*Discussion on Paper No. 6591\**

**Applications of soil mechanics in the design of stabilizing works for  
embankments, cuttings and track formations**

**Armand Huon Toms, B.Sc.(Eng.), M.I.C.E.**

**Donald Leonard Bartlett, B.Sc.(Eng.), F.G.S., A.M.I.C.E.**

FIG. 46: ASPINAL ROAD BRIDGE—PILING AND STRUTTING, TEMPORARY FOOTBRIDGE IN BACKGROUND

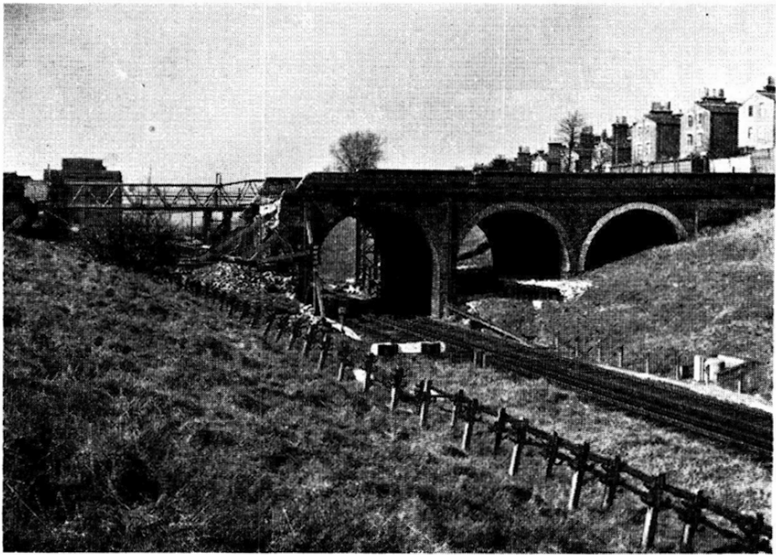
153. Fig. 46 showed the collapse and the strutting carried out to hold the other piers apart and sheet piling. The failure was due to shallow foundations on London clay; the clay softened up and, it was suspected, developed a slip circle (see Fig. 42) similar to that which the research people discovered on the other side. It had been possible to design sheet piling to stop collapse there. The D.E. had been fortunate to have in stock the temporary bridge shown, which had been put up the following weekend.

FIG. 47: HONOR OAK PARK STATION—REMEDIAL PILING

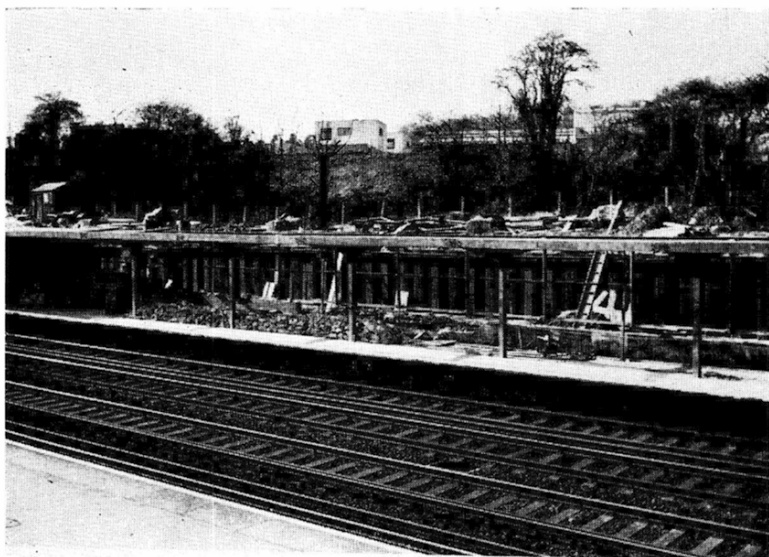
154. Another slip was illustrated in Fig. 47. It carried the station canopy and the back screen wall forward to foul the track. It was in London clay which had very slow creep, barely perceptible over many years. It had been loaded on top outside the Commission's property, causing a sudden movement with the disastrous results shown. Fig. 48 showed the top of the slip. The overloading had not been very large, about 7 ft, but it had been enough to make the toe go. The soil mechanics investigation into it was shown in Fig. 43.
